**ADDENDUM # 10**

**WEGO Transit and Fleet Operations Center Expansion**

**Request for Proposal No: RFP-22-2024-AD**  
**Issue Date of Addendum: January 16, 2025**  
**Proposal Submission Deadline: January 23, 2025 at 2:00 p.m. ET**

**ADDENDUM No.2**

2 Roof Plan - Enlarged Plan  
A2-200  
scale: 1: 125

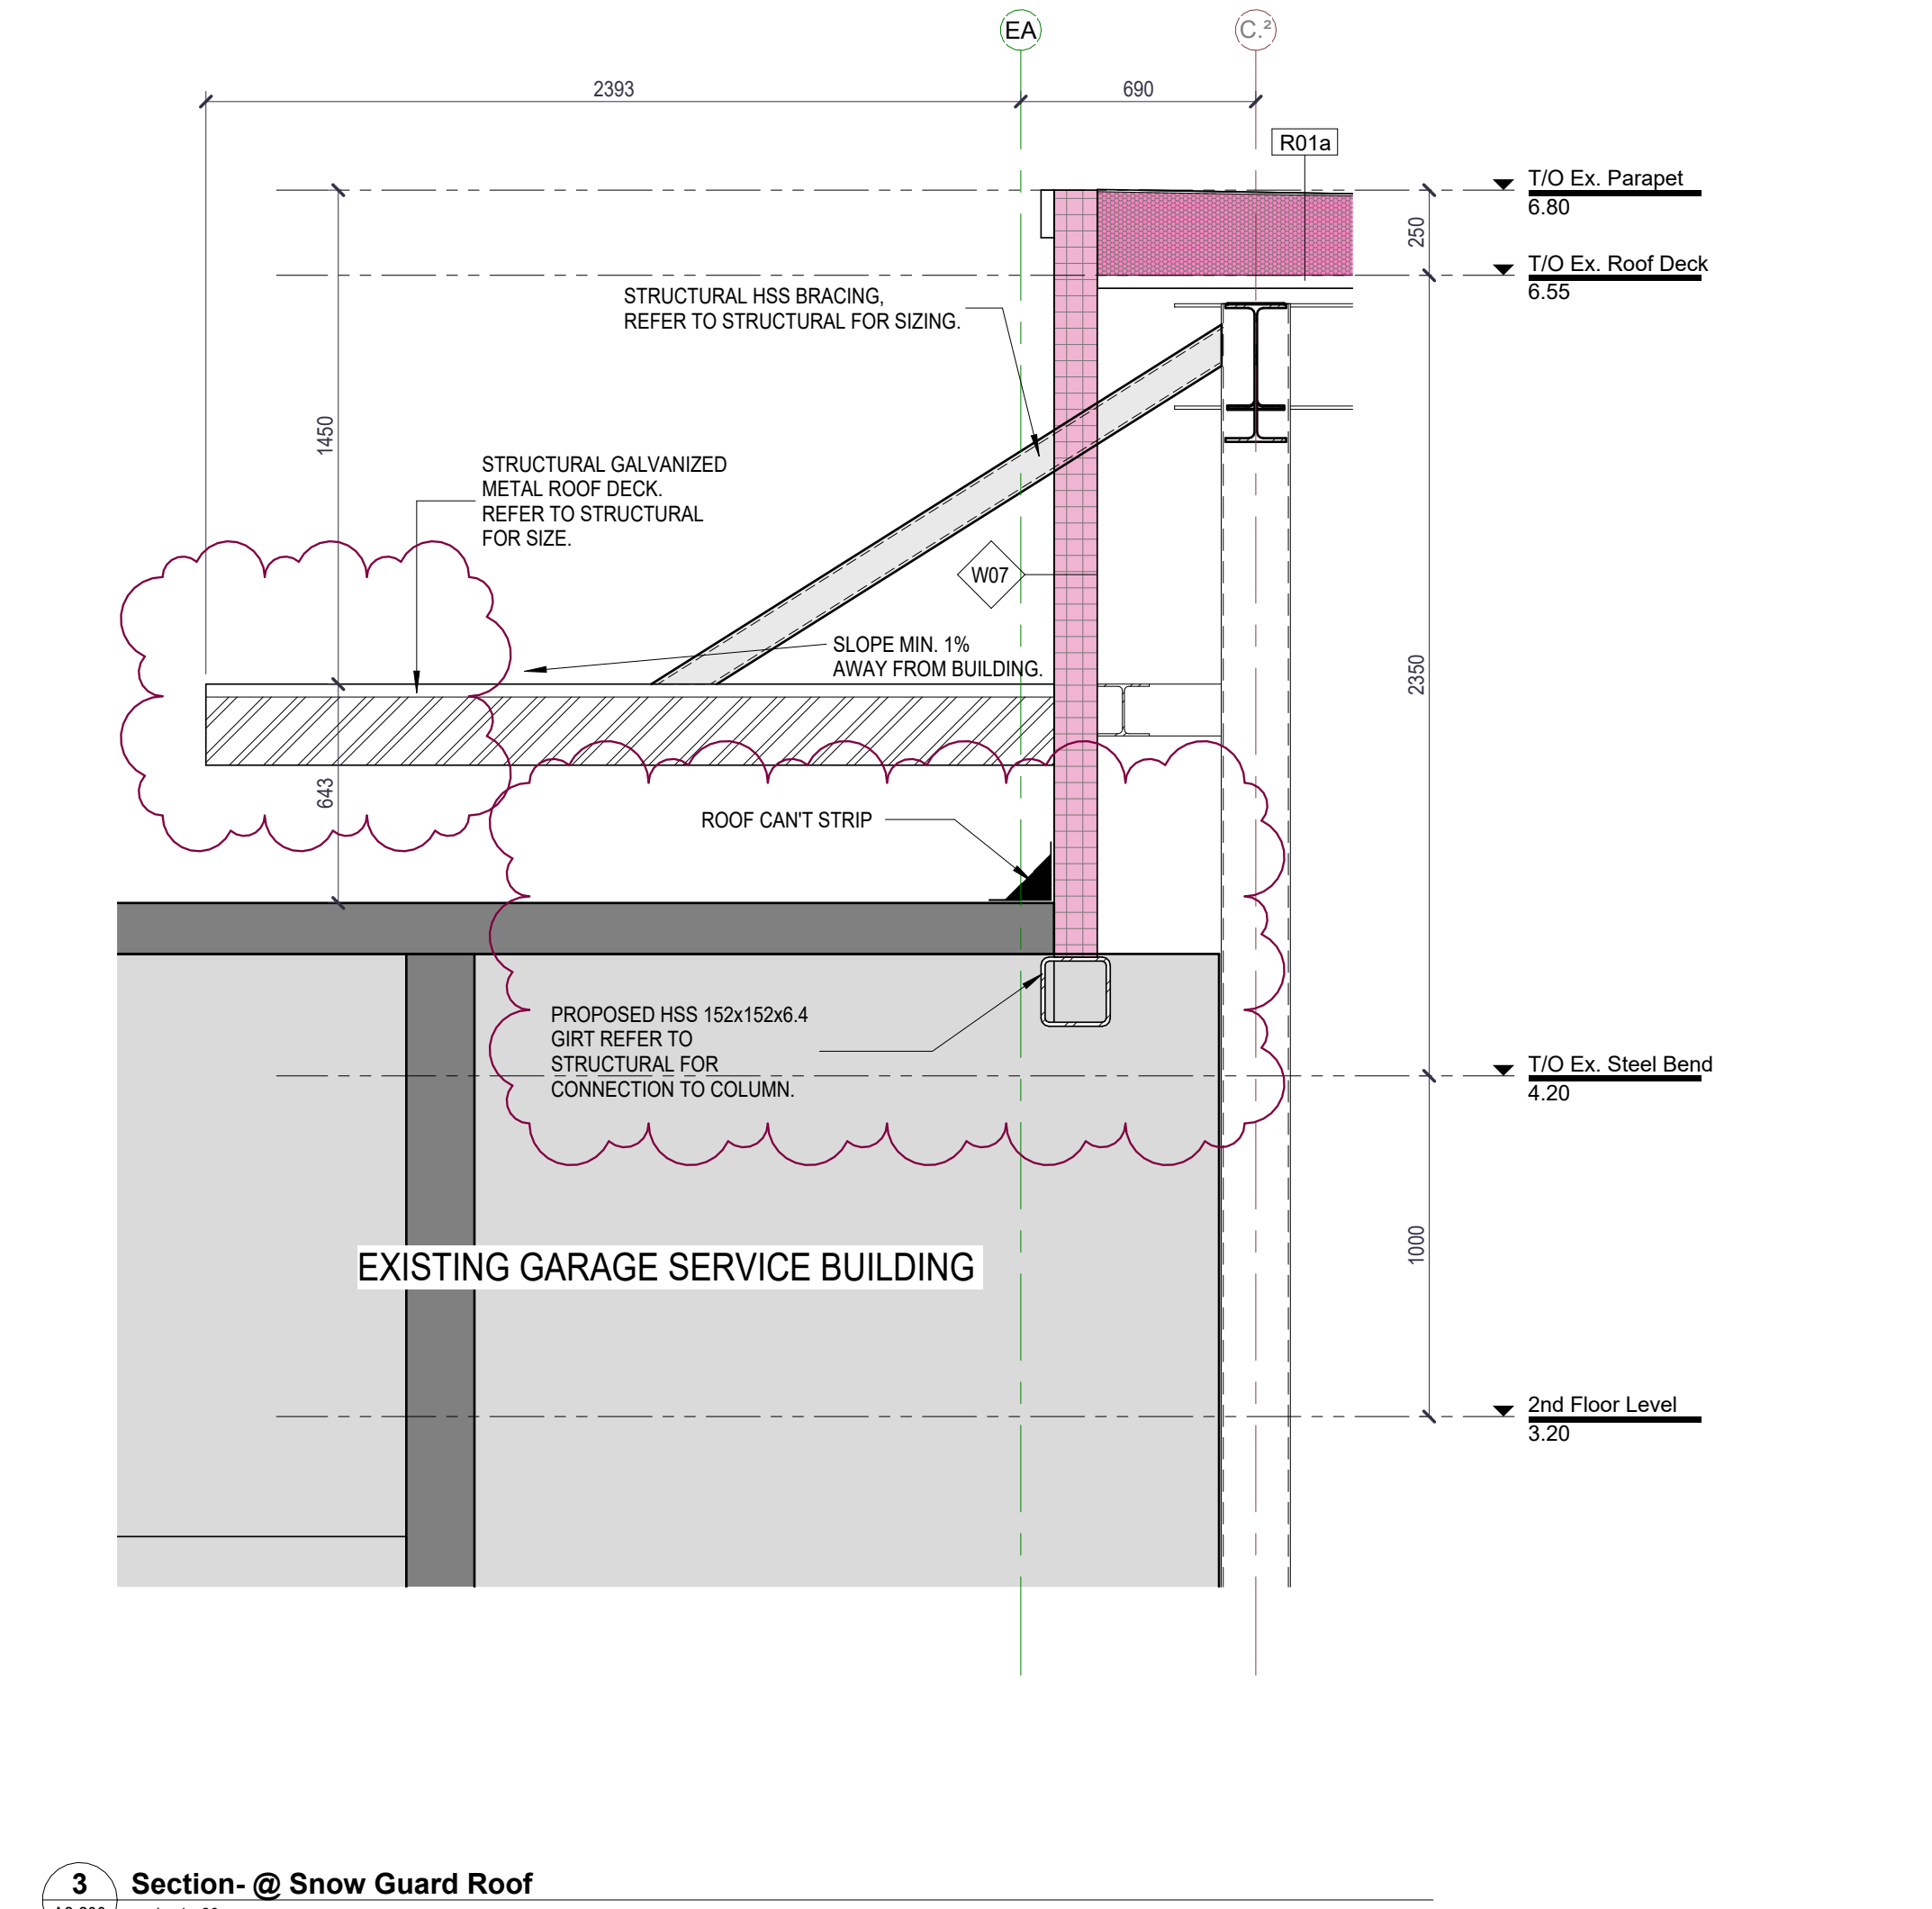
- 2.1 [Remove intumescent fireproofing detail.]
- 3.0 **Clarification: DRAWINGS – [A2-200] – [Roof Plans]**
  - 3.1 [A note was added to refer to mechanical for roof openings.]

- 3.2 [Parapet detail added at existing building for reference.]
- 4.0 **Clarification: DRAWINGS – [A5-300] – [Enlarged Section Details]**
  - 4.1 [Updated Window details to include C-channel Furring wall to match plans.]

SHEET NAME  
Windows & Interior  
Screens Schedule

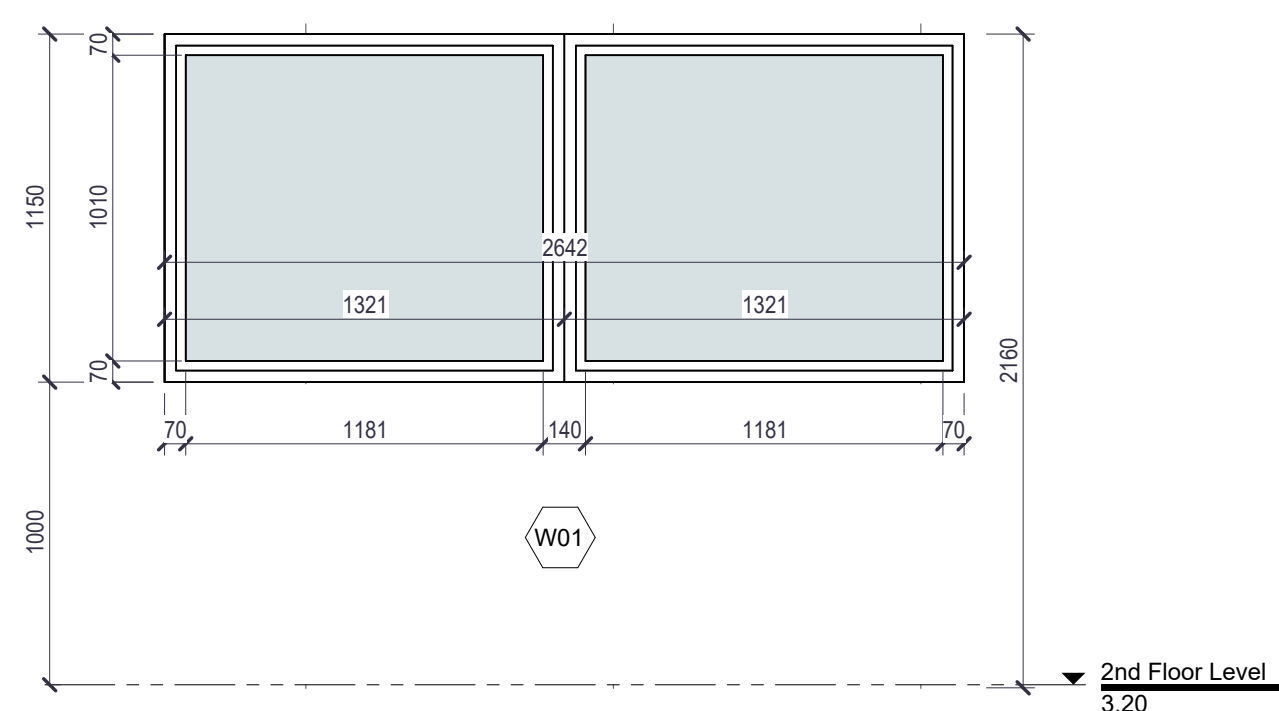
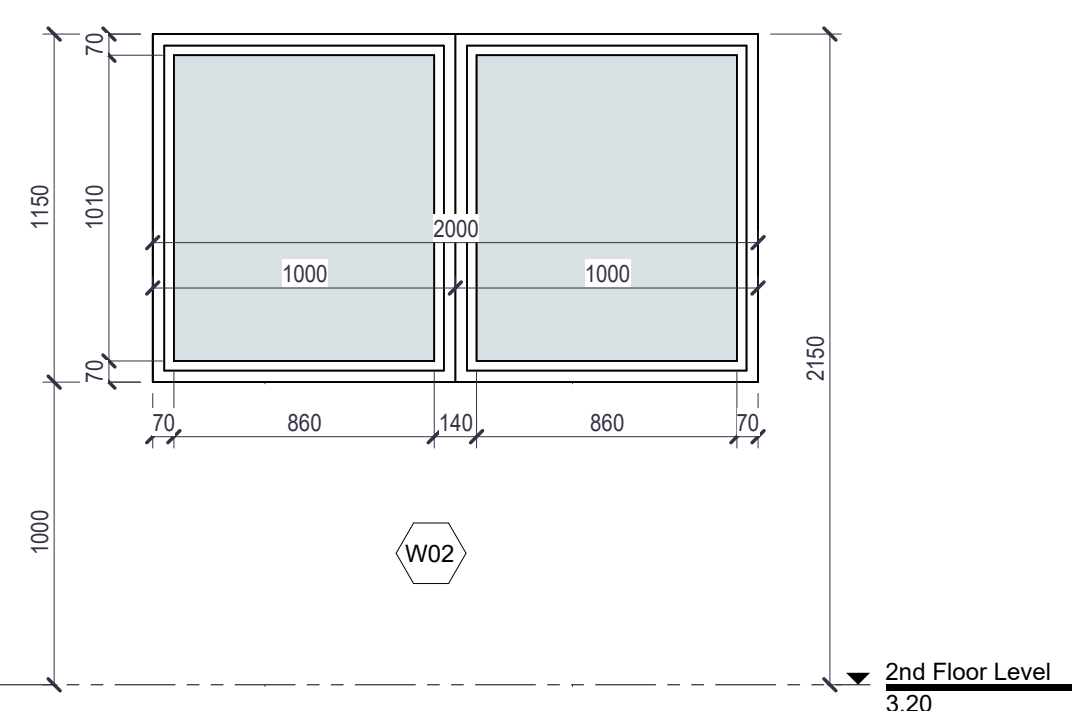
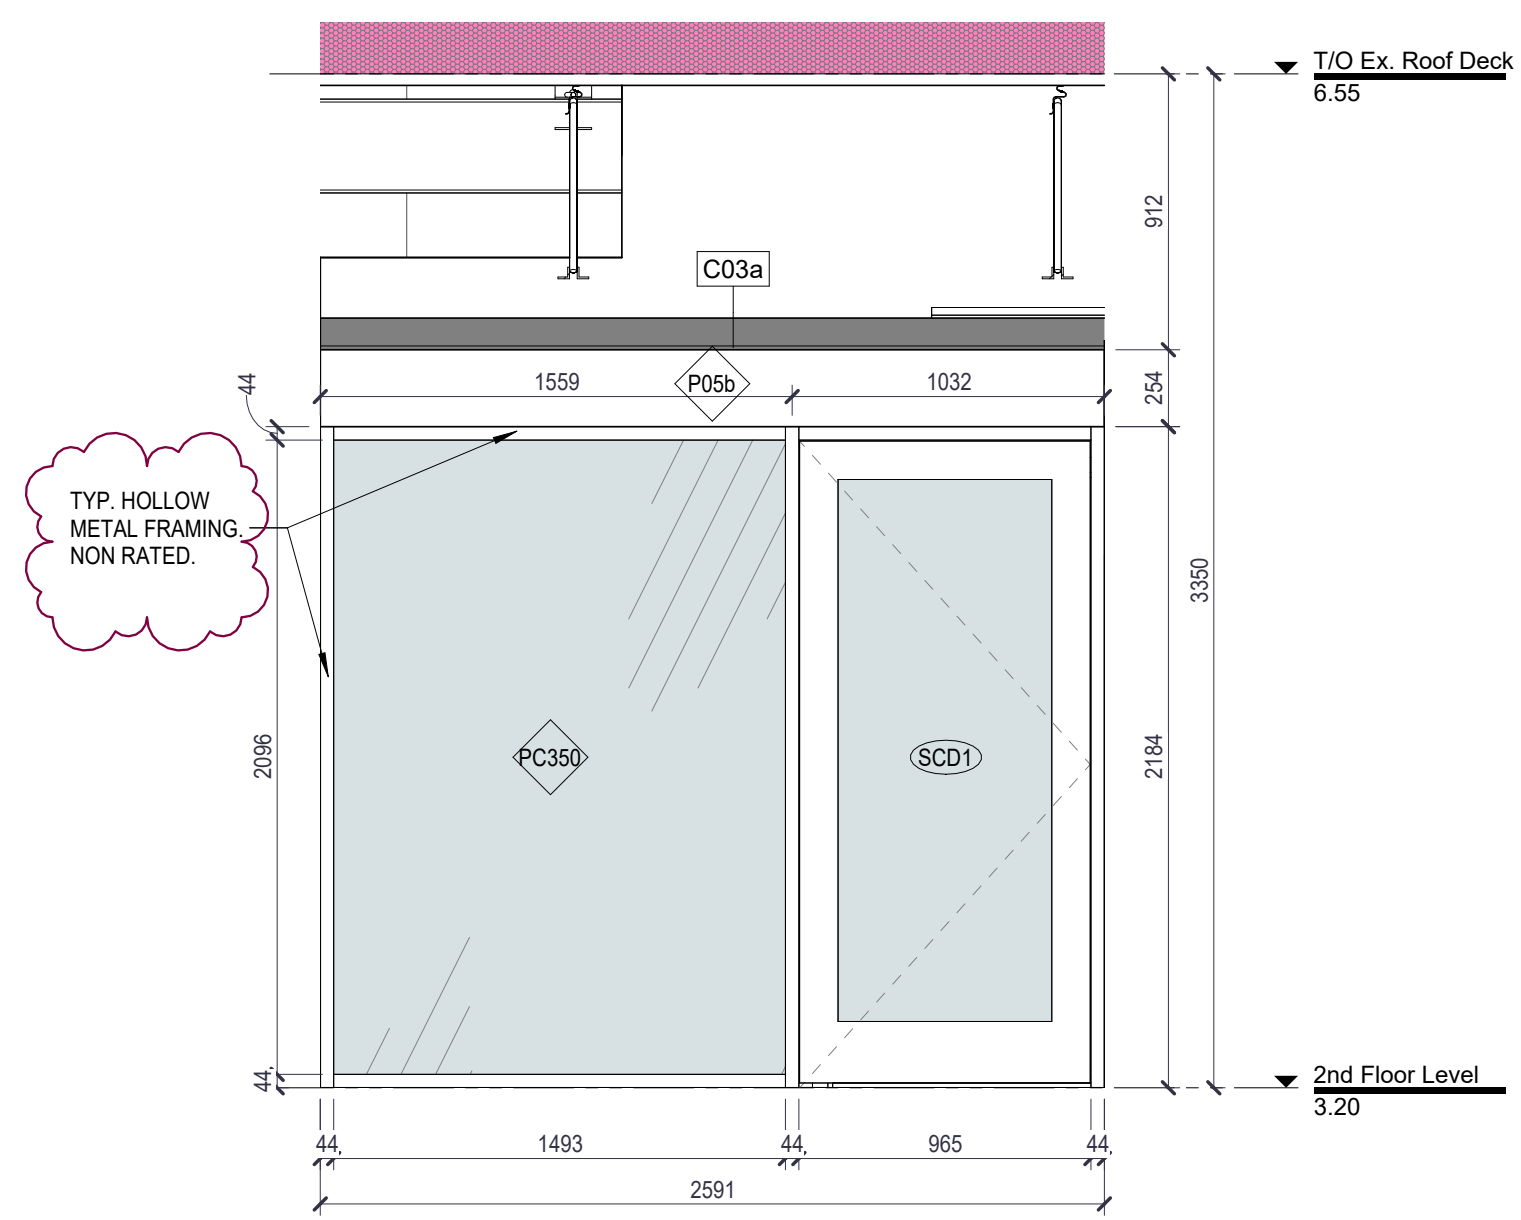
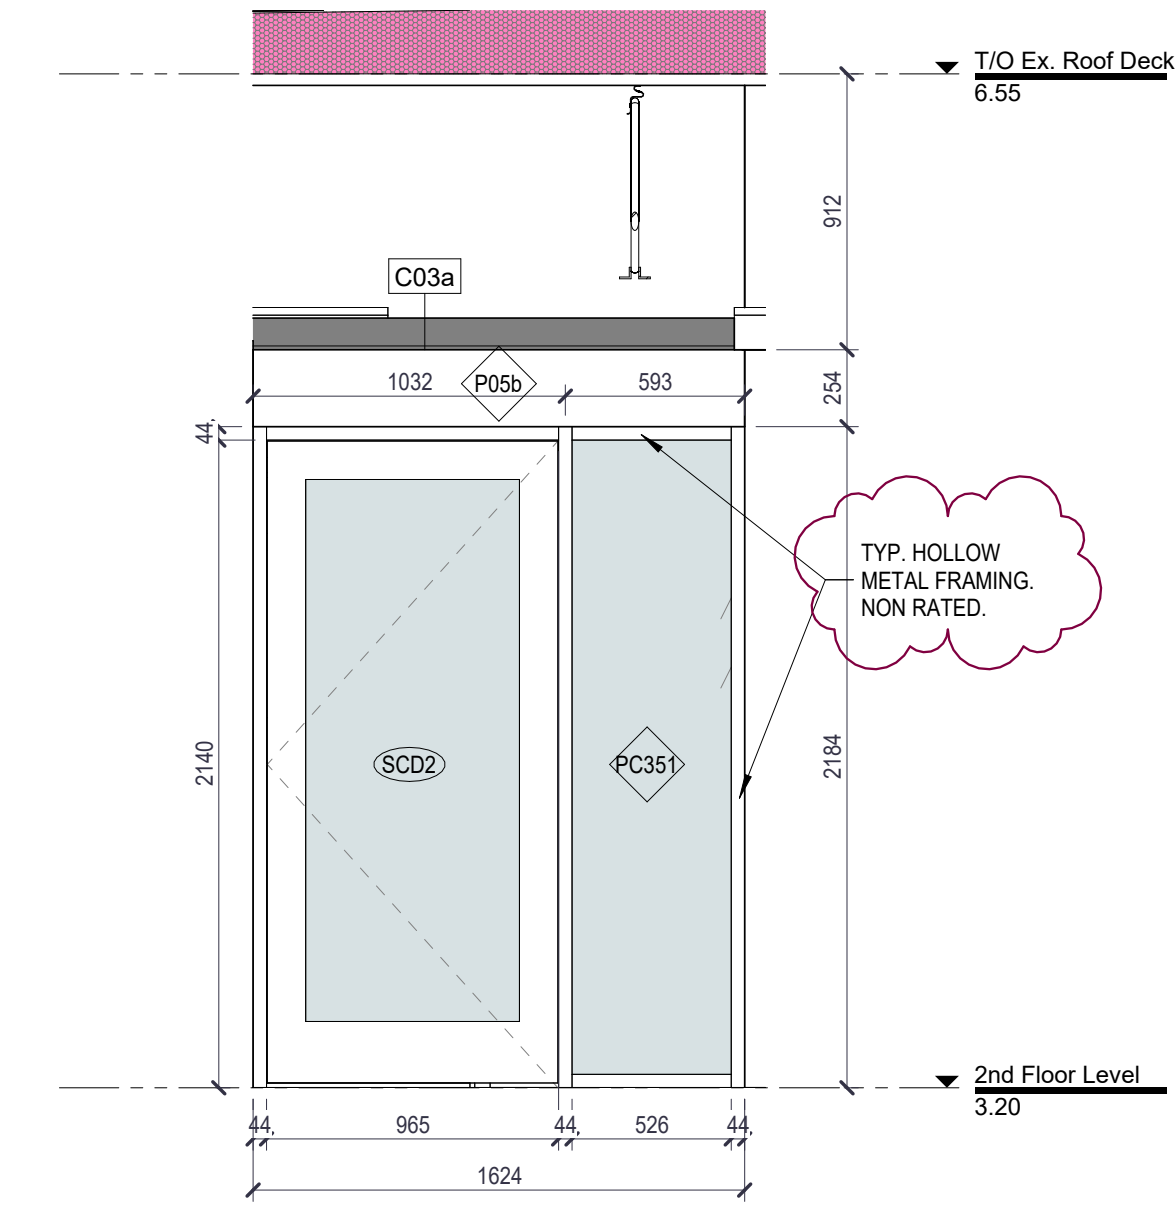
- 6.1 [Interior office screens show clarification of hollow metal framing.]
- 7.0 **Clarification: DRAWINGS – [A9-100] – [Typical Roof Details]**
  - 7.1 [Removed concrete rooftop pavers detail.]

**ANSWER:** NPC does not want PC350 framing system for this facility. Consultant to revise for hollow metal screens. Refer to addendum architectural drawing.
